Before Environment Canterbury Regional Council

In the matter of the Rangitata Diversion Race Consents

Statement of Evidence of Darryl Murray Hicks for Central South Island Fish and Game Council

11 April 2018

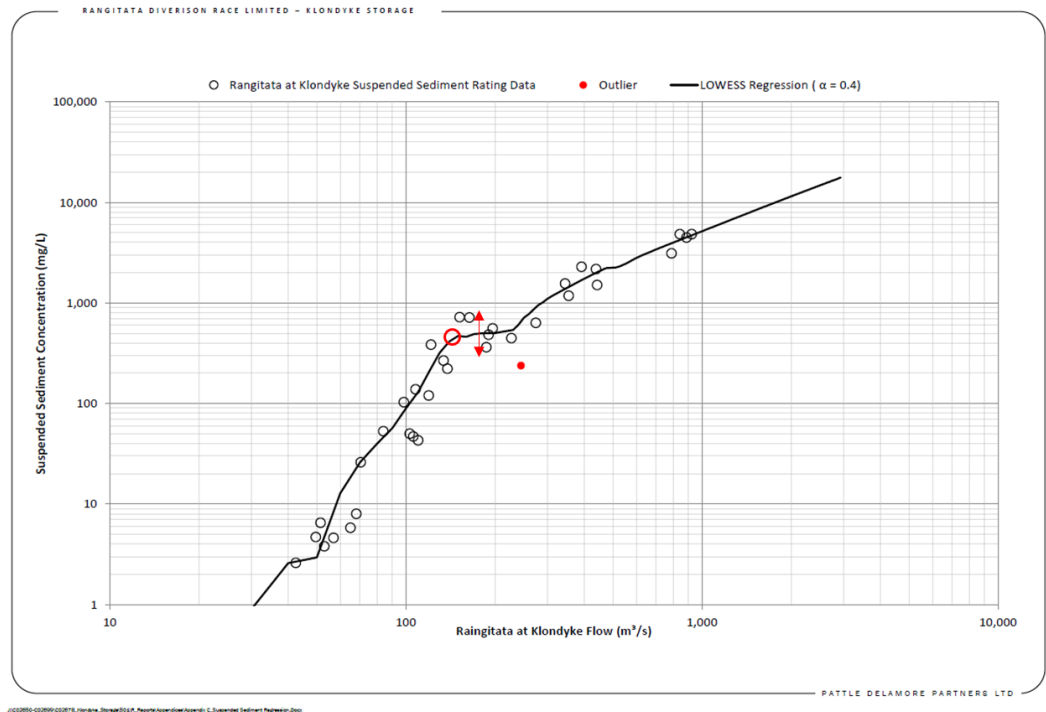
- 17 In my Figure 1 below, I reproduce the graph of this relationship from Appendix C of Pattle Delamore partners (**PDP**) Ltd (2016). The black line shows the relationship fitted by PDP using the Locally Weighted Scatterplot Smoothing (**LOWESS**) method. I have added a red circle to show the key point

on this curve at a discharge of $140 \text{ m}^3/\text{s}$, which is the approximate current discharge threshold associated with flushing the sand trap. My double-ended arrow shows the range of data-scatter about this curve, which equates approximately to a factor of three.

- 18 In my view, PDP have “over-fitted” the curve to the data by using too small a “stiffness” factor, which controls the “window” of data considered in the LOWESS fitting. A larger stiffness factor would have used more data-points and so would have smoothed-out the “kinks” and represented the overall trend better. However, despite this, the concentration values extracted by PDP at $140 \text{ m}^3/\text{s}$ (410 mg/l) appears to be reasonably close to where a smoother trend would run – so I expect insignificant impact on their derived estimates of long-term average sediment take into the RDR and the proportion diverted into the KSP.

- 19 What is of more importance is that use of this sediment rating curve to estimate the “background” suspended sediment concentration in the Rangitata River at any time when the sand trap is being flushed takes no account of the considerable scatter shown by the data around the curve, which is quite typical of such curves and reflects variability in the supply of water and sediment to the river upstream. For example, if flushing occurs on a flood recession at a river flow just above $140 \text{ m}^3/\text{s}$ as measured at the Klondyke flow recorder, the background concentration in the river need not be 410 mg/l as considered by PDP but could be anywhere between about 750 and 250 mg/l . In the latter case, the flushing discharge would be conspicuously muddier than the river it was entering, although this would fade in the course of several kilometres downstream as the flush discharge mixed with the river flow.

- 20 I conclude that the sand trap flushings could at times be more conspicuous in the river than anticipated by PDP.

Figure 3: Relationship between suspended sediment concentration (**SSC**) and water discharge for Rangitata River at Klondyke, with rising-stage and falling-stage data distinguished.

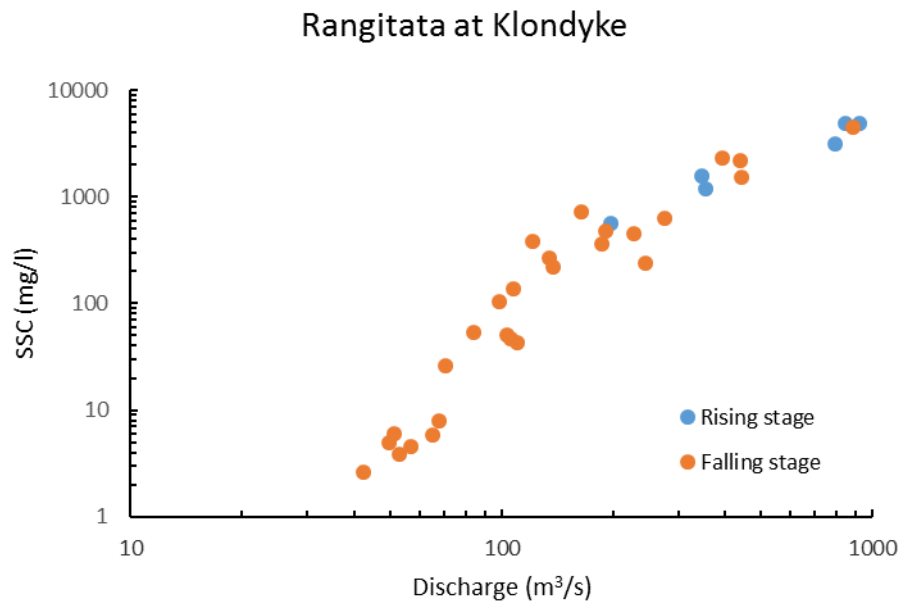
- 38 With regard to the data shown in Figure 1, I have identified whether the measurements were made on rising or falling stages. These are identified on Figure 3. This shows that while most of the measurements were made during falling stages, the few rising-stage data points plot in the same “space” as the falling stage points. So, there is no evidence in these data of any significant and

systematic difference between rising- and falling-stage concentrations in the Rangitata River.

Figure 4: Discharge and turbidity in Rangitata River at Klondyke during three freshes in March-April 1999. Lower plot traces the relationship between turbidity and discharge through each event. Dashed arrowed curves show the direction of time progression.

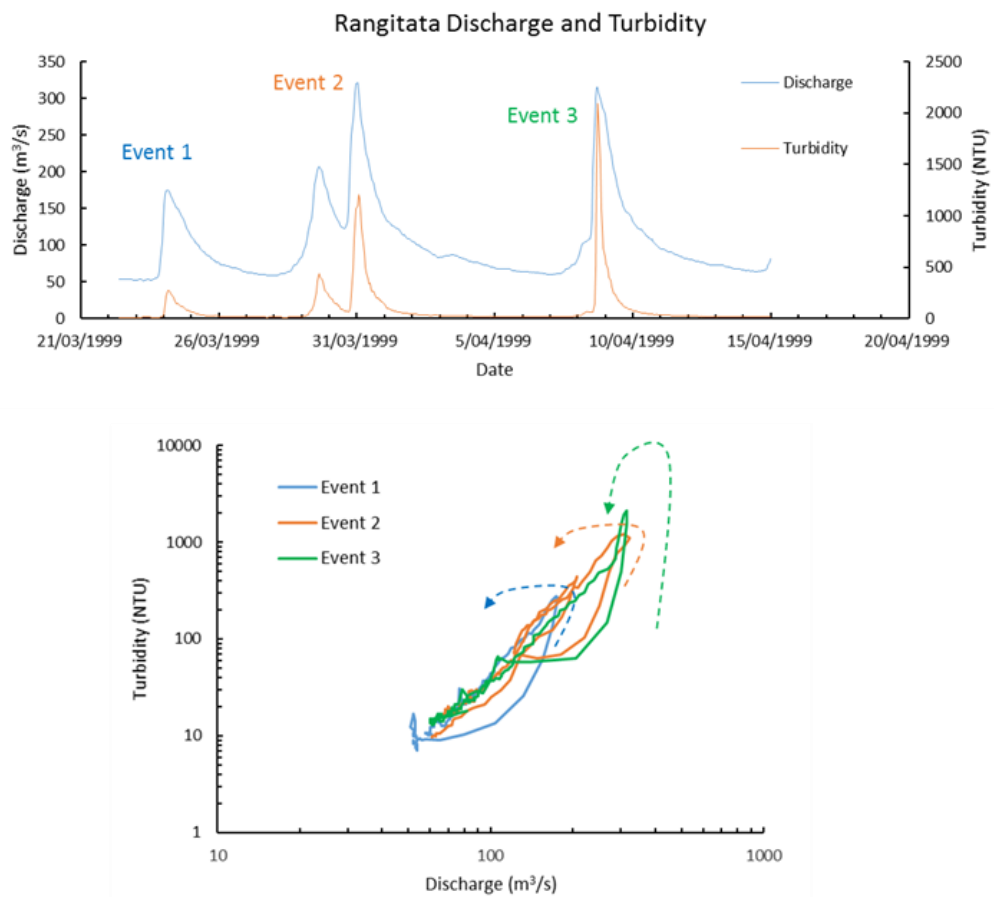
- 39 The second line of evidence stems from a record of turbidity collected from the Rangitata River near the RDR over the period 16 October 1998 through 30 April 1999. Although provided to me by Fish & Game, my understanding is that this record was collected by the RDR Management Ltd. From my experience deploying turbidity sensors on many rivers, it is reasonable to assume an approximately linear relationship between turbidity and SSC, thus turbidity may be treated as a proxy for SSC.

- 40 I have examined the phasing of turbidity and water discharge over high flow events captured by this turbidity dataset. I show in Figure 4 three freshes over the period 22 March to 14 April 1999 for which the data appear reliable. The top plot shows the “hydrographs” for discharge and turbidity. The lower plot traces the relationship between turbidity and discharge through each event. The dashed arrowed curves show the direction of time progression through each event. In all three events the trace follows an anti-clockwise “loop”, showing that turbidity values were lower on rising stages compared to falling stages.

- 41 Thus, I see no evidence that the Rangitata tends to carry less suspended sediment on falling stages – indeed, if anything it carries more. On that basis, I conclude that restricting water takes and sand trap flushes to falling stages would not mitigate the risk of fine sediment deposition in dead zones downstream. In contrast, flushing and taking water only during rising stages would mitigate this risk by providing more competent flows and more time for dispersing the flushed sediment and residual river sediment downstream during recessions.
- 42 I note that this conclusion around optimal phasing of water takes and flushes relates only to the risk of downstream fine sediment deposition and does not consider other effects.
